TOWN OF NEWBURGH PLANNING BOARD TECHNICAL REVIEW COMMENTS

PROJECT NAME:SHOPPES AT UNION SQUARE PHASE IIIPROJECT NO.:23-16PROJECT LOCATION:1217 & 1219 ROUTE 300SECTION 96, BLOCK 1, LOT 6.2 & 11.11REVIEW DATE:7 AUGUST 2024MEETING DATE:15 AUGUST 2024PROJECT REPRESENTATIVE:KARC PLANNING CONSULTANTS

RE: 1217 & 1219 NYS Route 300
 Parcel ID# 96-1-6.2 & 96-1-11.1
 Newburgh Shoppes Phase III - Site Plan / Subdivision Applications

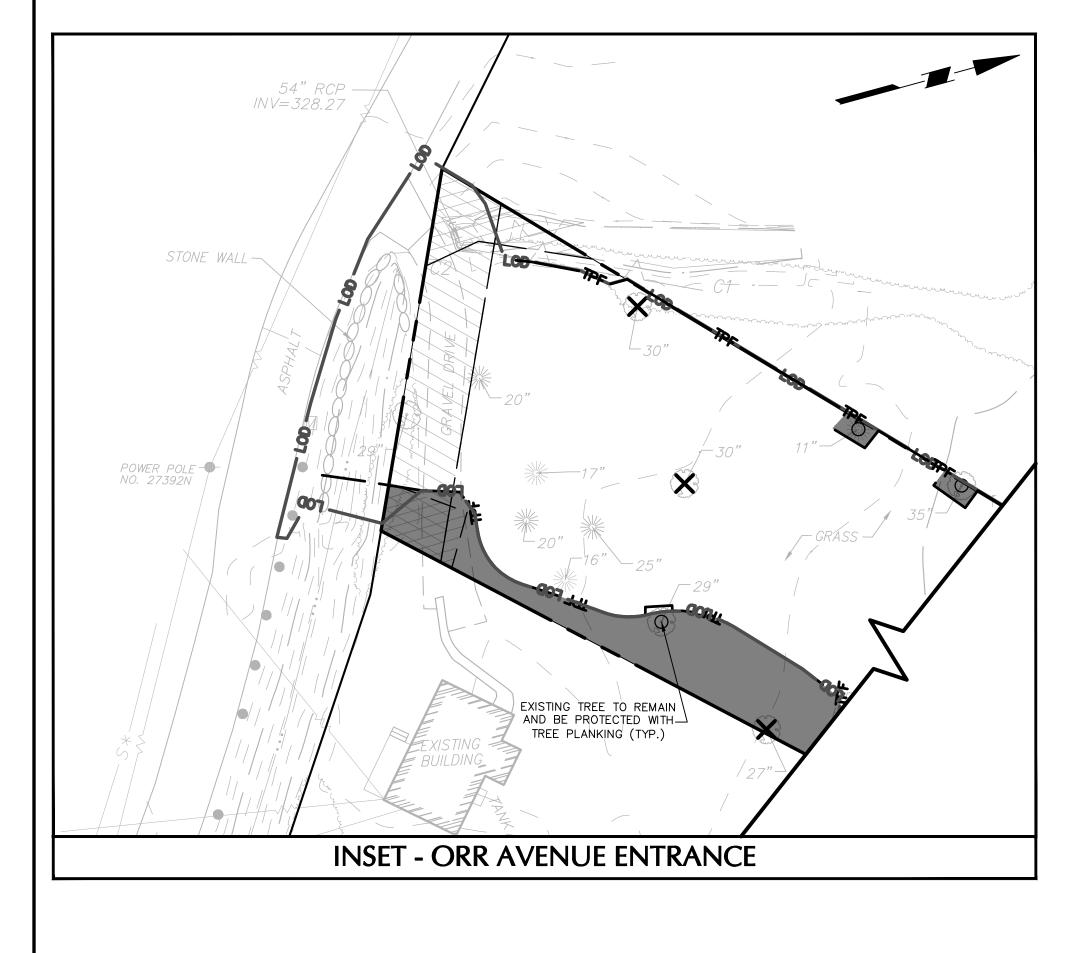
- 7. The City of Newburgh clause acceptance letter is required.
- 8. The tree preservation plan submitted must list the size and species of each identified tree. An abbreviated chart has been provided on the plan.

- 9. The percentage of specimen trees to be removed must be calculated based on the total number of specimen trees on the site.
- 10. The chart does not address Protected Trees as identified in the ordinance.

- 11. The ordinance requires the plan to identify the qualifications of the person performing the tree survey.

<u>Response:</u> Please refer to Tree Preservation Plan (Sheet 16.04) prepared by Langan Engineering dated July 26 2024 amended July 30, 2024 included in this submission.

Filename: C: \bms\langan-pw-01\d0576961\009133114-0502-CS101-0301.dwg Date: 7/30/2024 Time: 14:59 User: nrotundo Style Table: Langan.stb Layout: 20.04

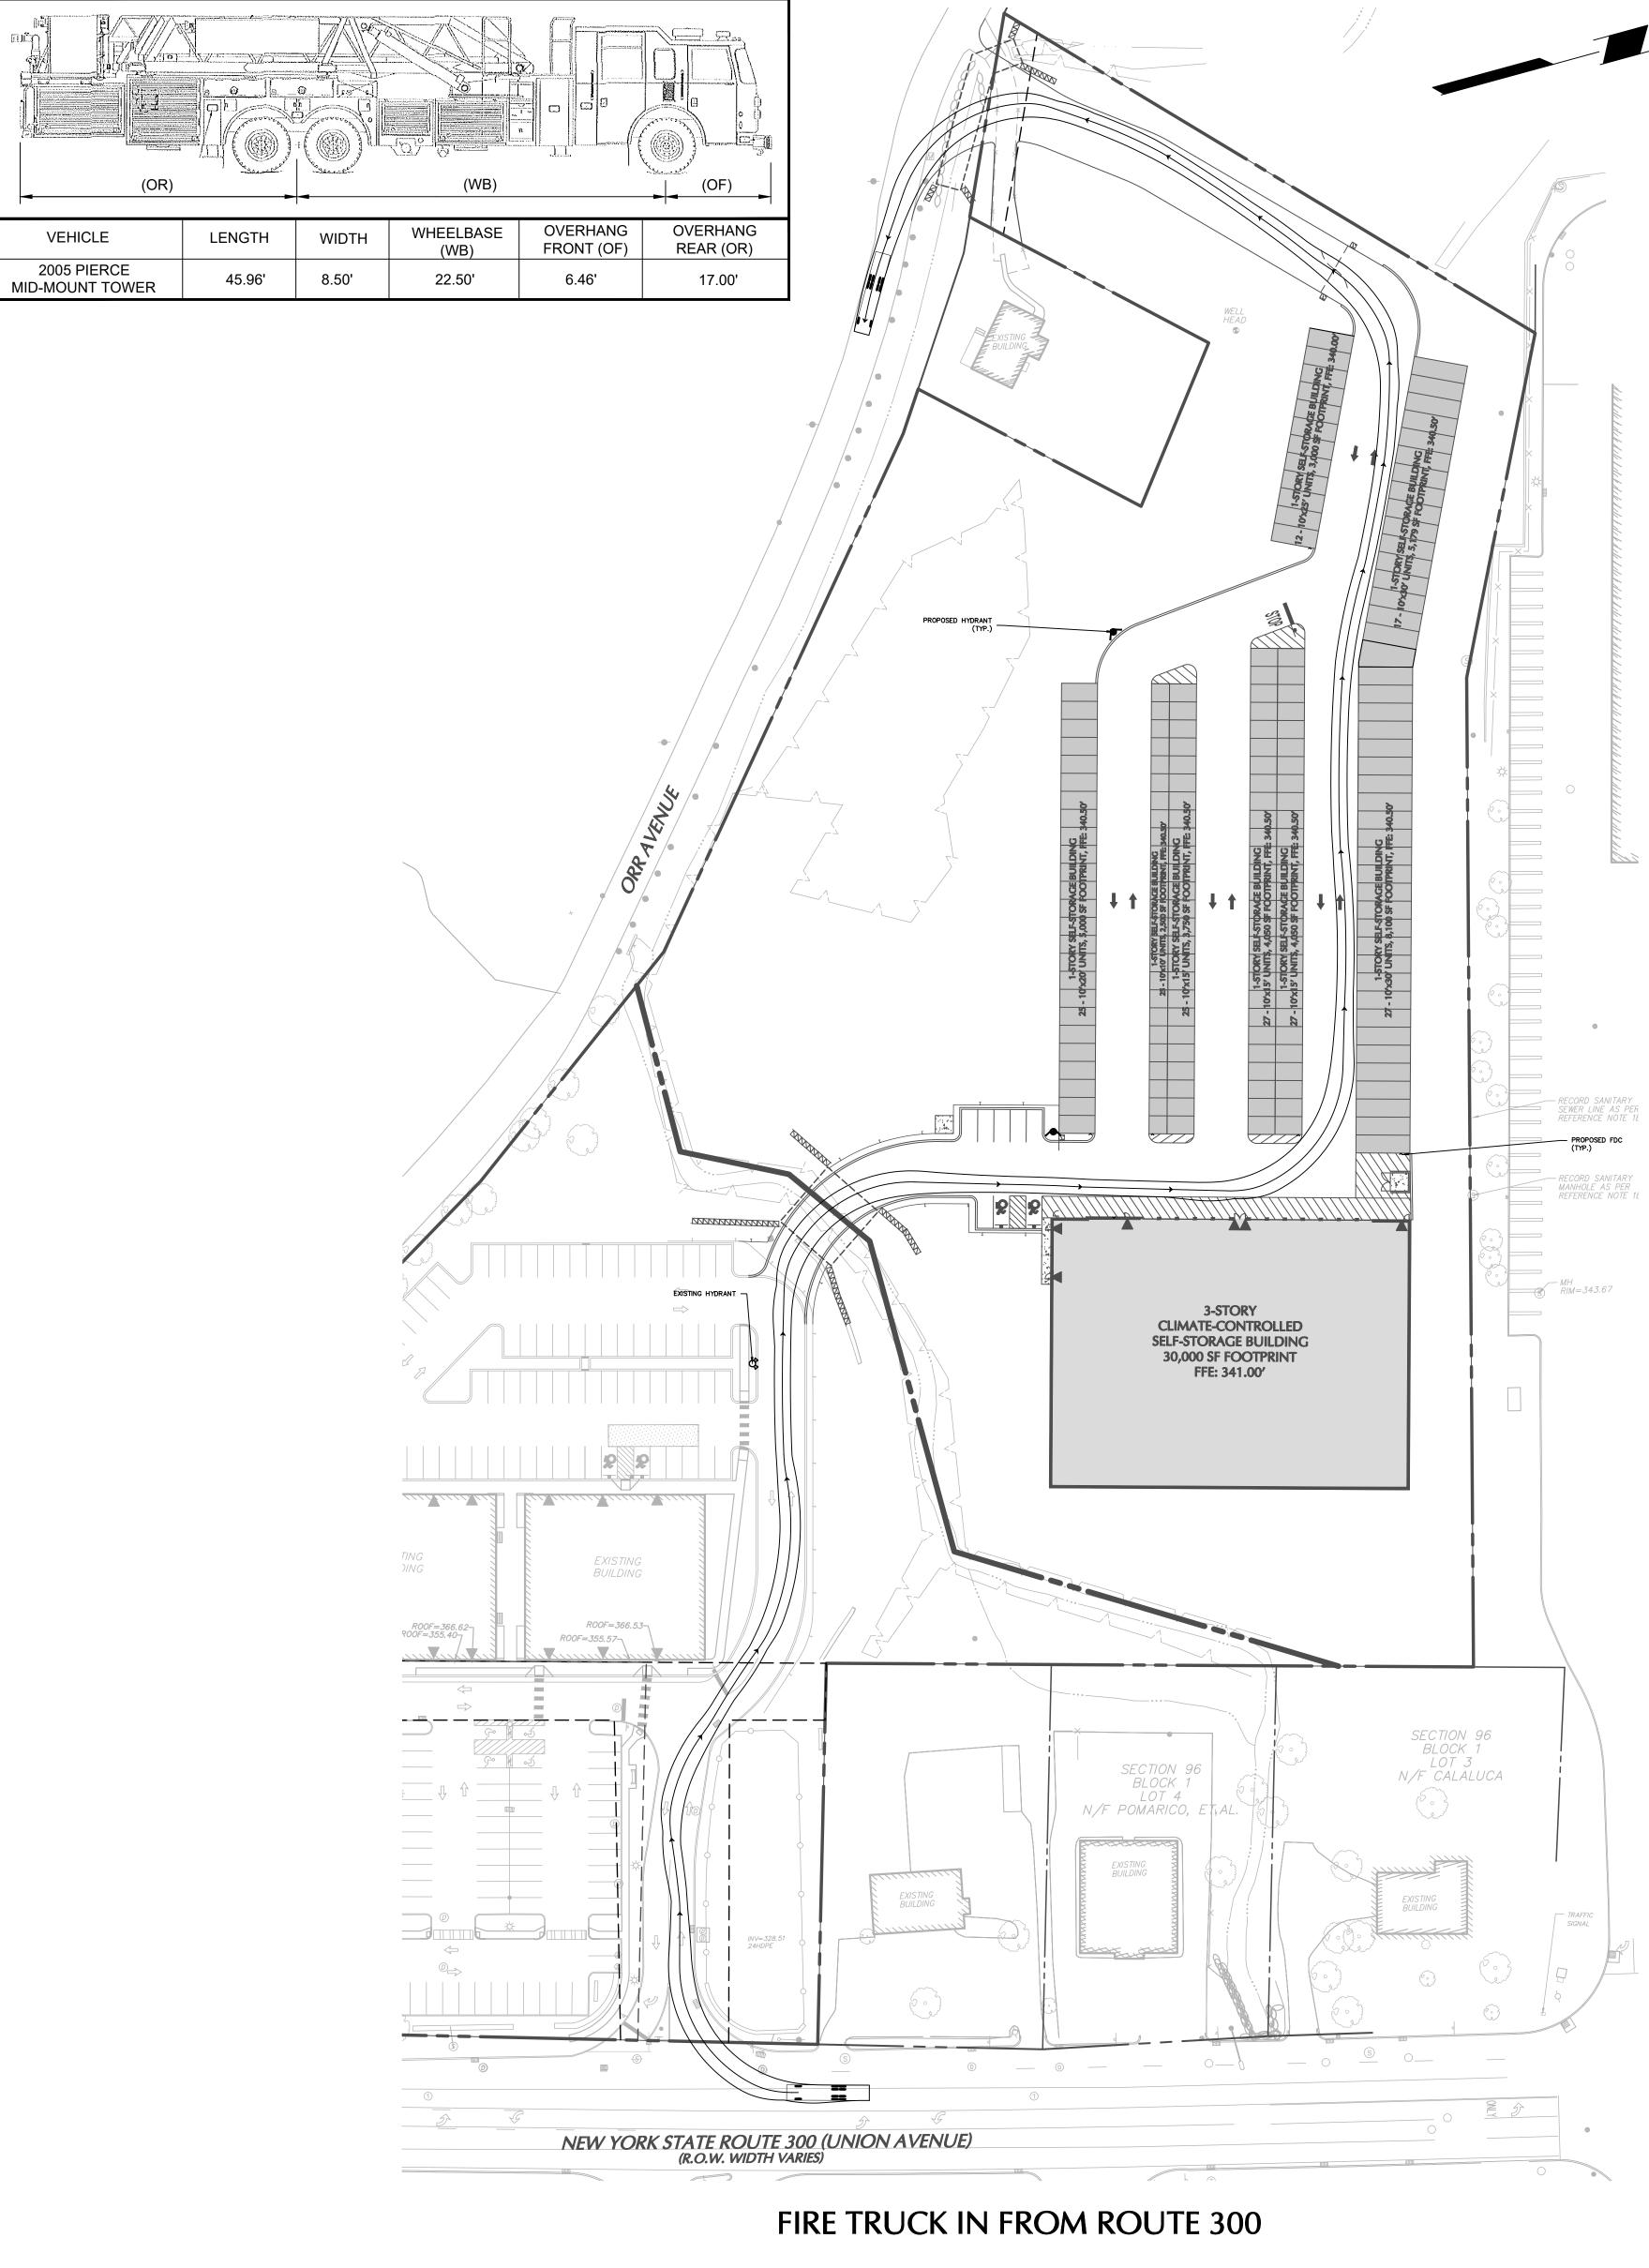
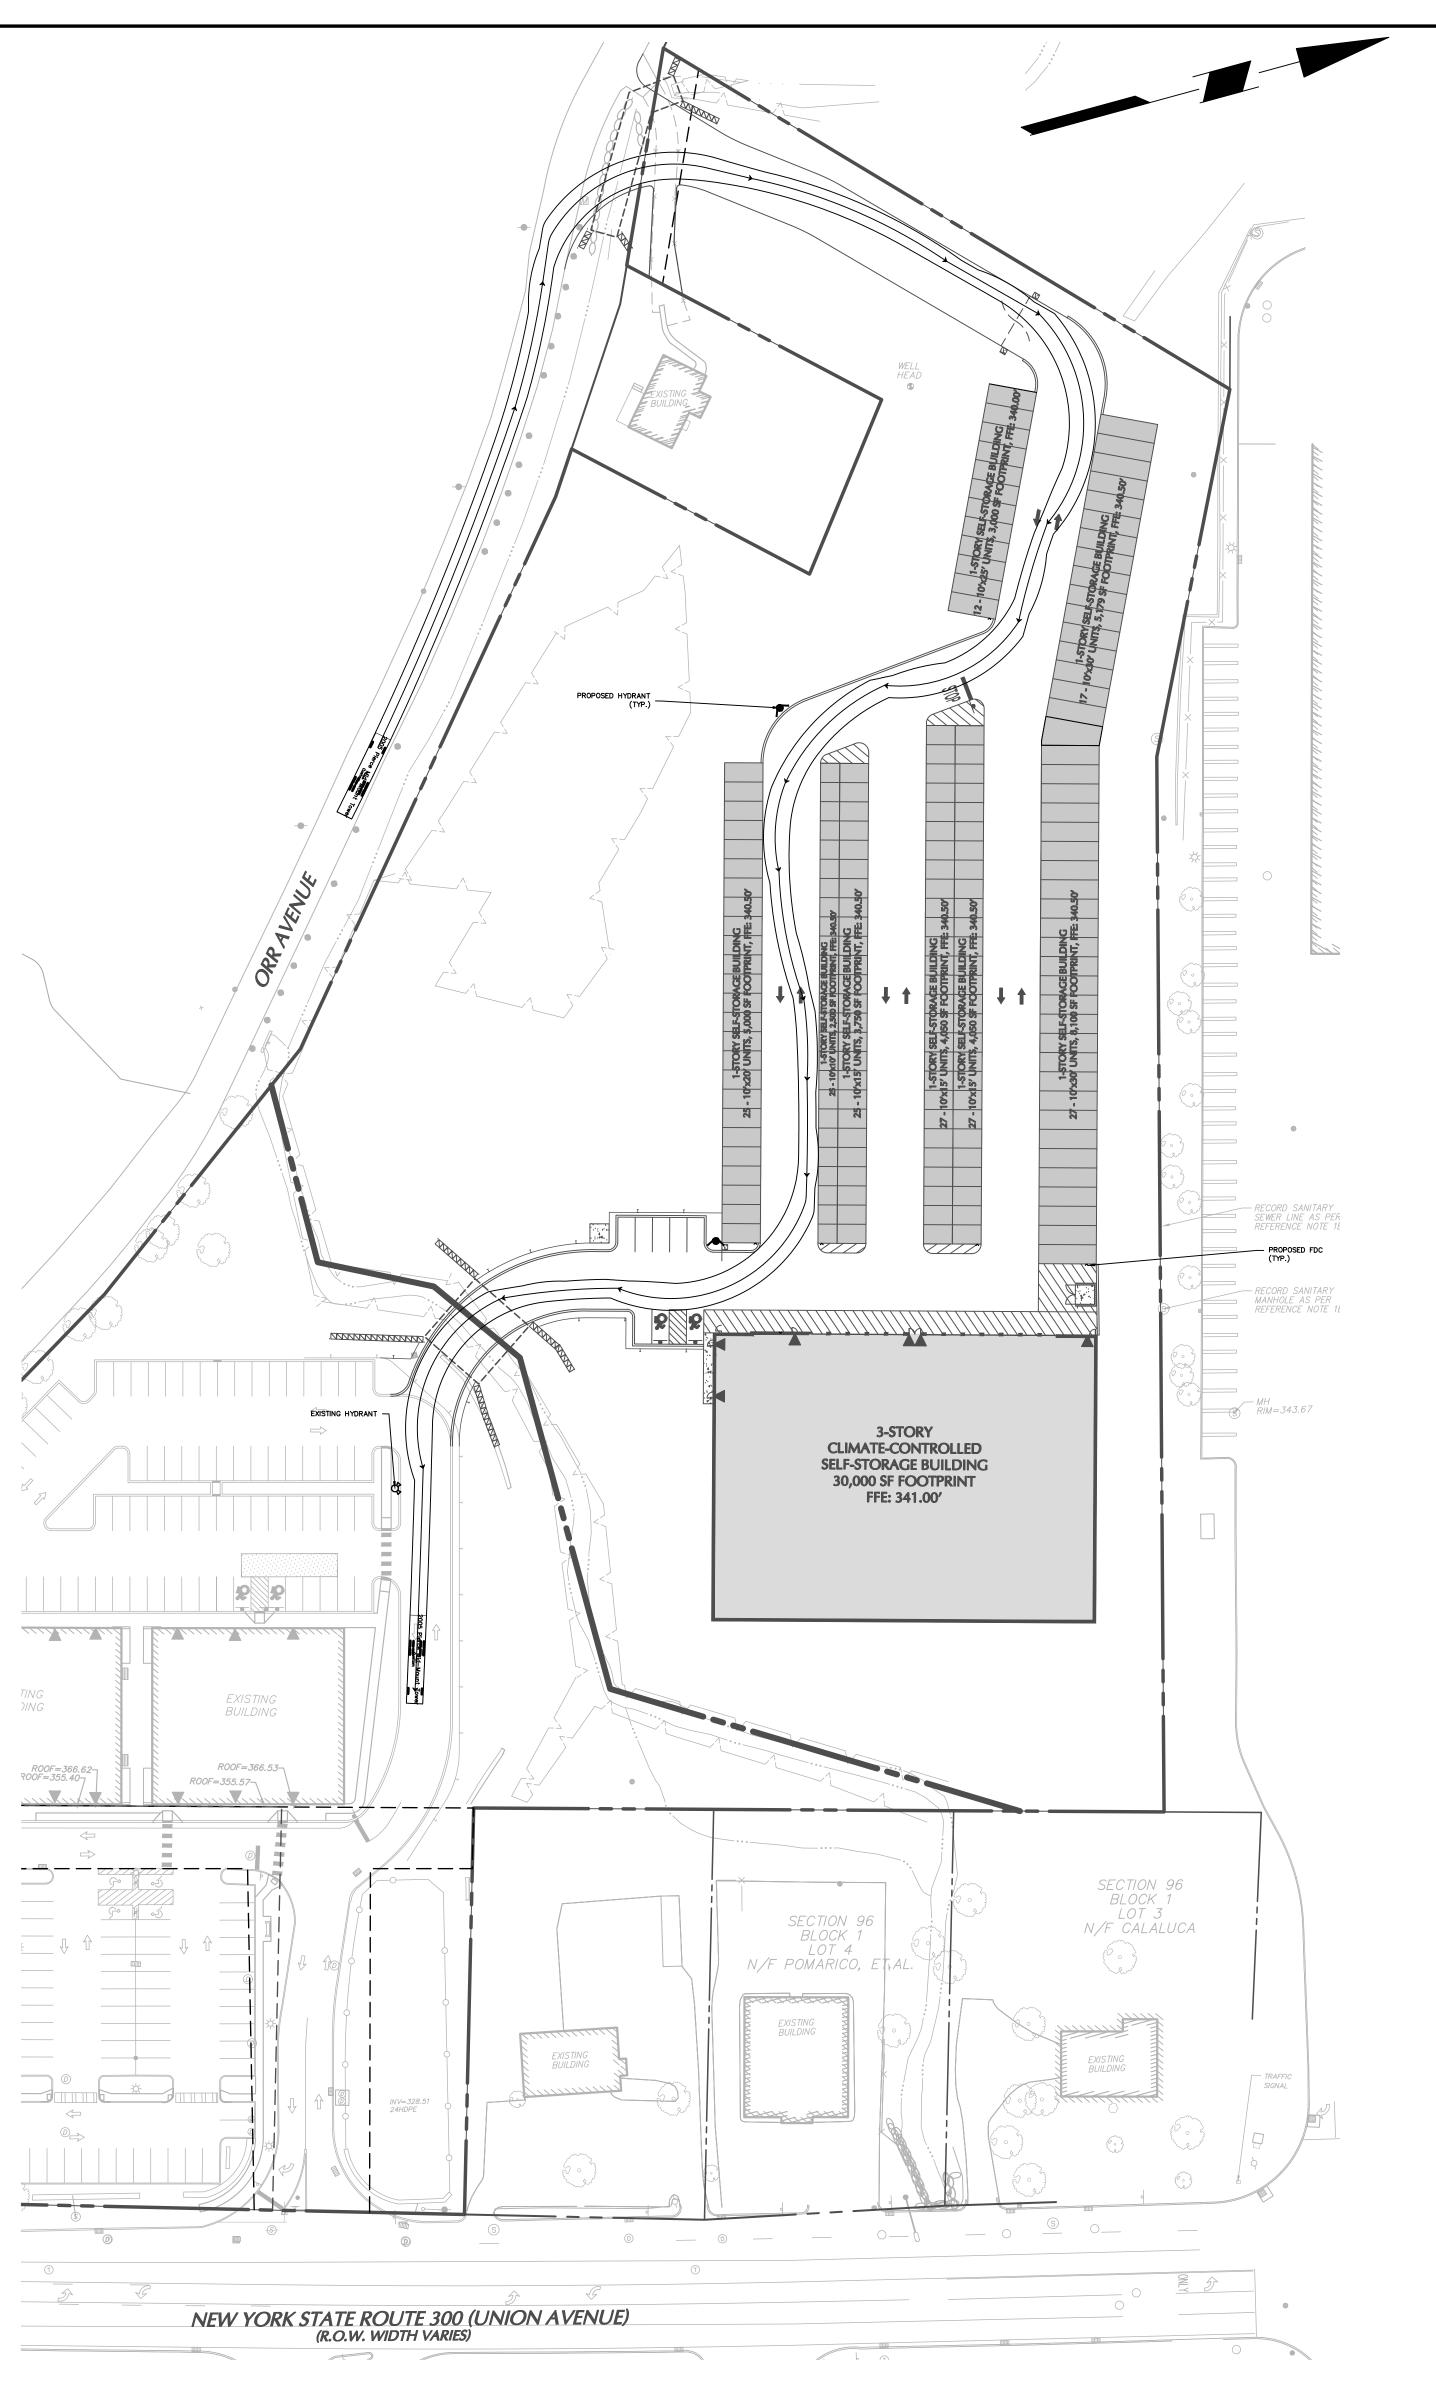
2. Hydrant locations.

<u>Response</u>: Hydrants are now shown on the Site Plan (Sheet 20.04), Utility Plan (Sheet 22.04), and Fire Truck Plan (Sheet 20.14) included in this submission package.

<u>Response</u>: Hydrants are now shown on the Site Plan (20.04), Utility Plan (Sheet 22.04), and Fire Truck Turning Analysis Plan (Sheet 20.14) included in this submission package.

<u>Response</u>: Please Refer to the Site Plan (Sheet 20.04) for the location of loading and unloading zone. A representative of KARC will coordinate a review of the project with the Fire Department to identify any specific questions.
